Edinburgh Park Arena: 24/00820/FUL

Response from Spokes Planning Group, March 2024

Impacts on Quiet Route 8:

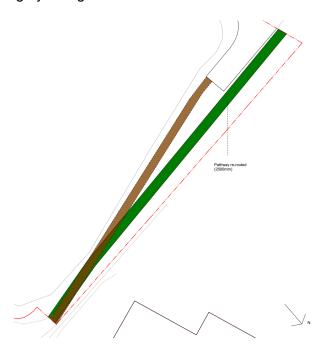
The proposed site is bounded on 3 sides by the existing Quiet Route 8 which links the Roseburn (for the City Centre) to Edinburgh Park via mainly segregated cycleways / paths. This is a primary and high quality link that Spokes would like to see improved. Given the amount of housing due to be built at Edinburgh Park it is very important the capacity is adequate for this especially given the Council's own modal share targets.

The proposals appear to do nothing to improve the adjacent path under the railway apart from cutting back vegetation. Spokes is concerned that during event start and end it will be impossible for cycle users to use the underpass safely.

There seems to be a reliance on core paths and a lack of knowledge on the Quiet Routes network in the Transport Assessment. The proposed realignment of the path to the north of the Arena site is shown at an unacceptable 2.5m width. This should be 4m wide at minimum per Cycling by Design 2021.

The diagrams in the Transport Statement provide no reassurance that the realigned path connects to any meaningful routes further westwards. So as such we find it difficult to support this part of the proposal.
